UNITED STATES PATENT AND TRADEMARK OFFICE

APPLICATION NO.	FILING DATE	FIRST NAMED INVENTOR	ATTORNEY DOCKET NO.	CONFIRMATION NO.
09/398,652	09/17/1999	WILLIAM A. SAMARAS	042390.P5120D	1359

Office Action Summary	Application No. 09/398,652	Applicant(s) SAMARAS ET AL. ed	
	Examiner Rick K. Chang	Art Unit 3729

DETAILED ACTION

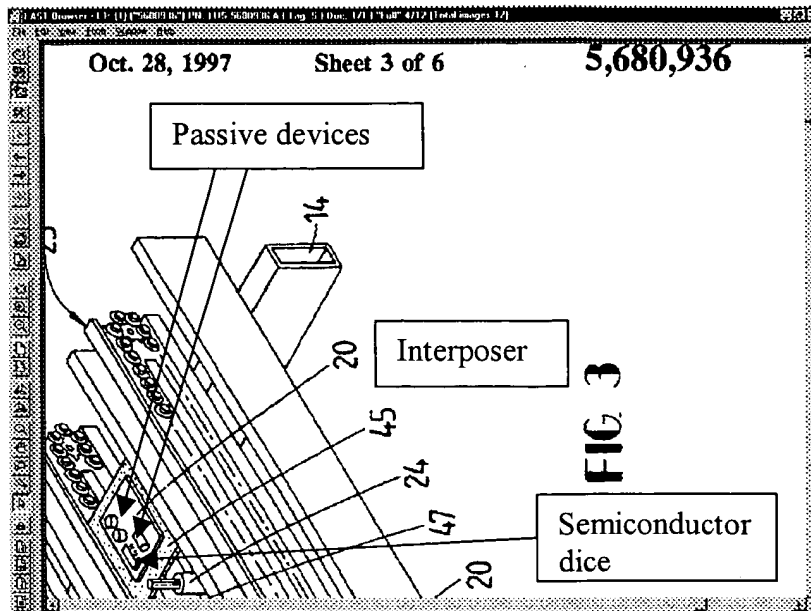
Beers discloses coupling at least one passive device (see annotated Fig. 3 below) thereby regulating voltage and current to the electronic dice.

Furthermore, it would have been obvious to one of ordinary skill in the art at the time the invention was made to modify Seidel by coupling at least one passive device to the first surface of the interposer, as taught by Beers, for the purpose of regulating voltage and current to the electronic chip.
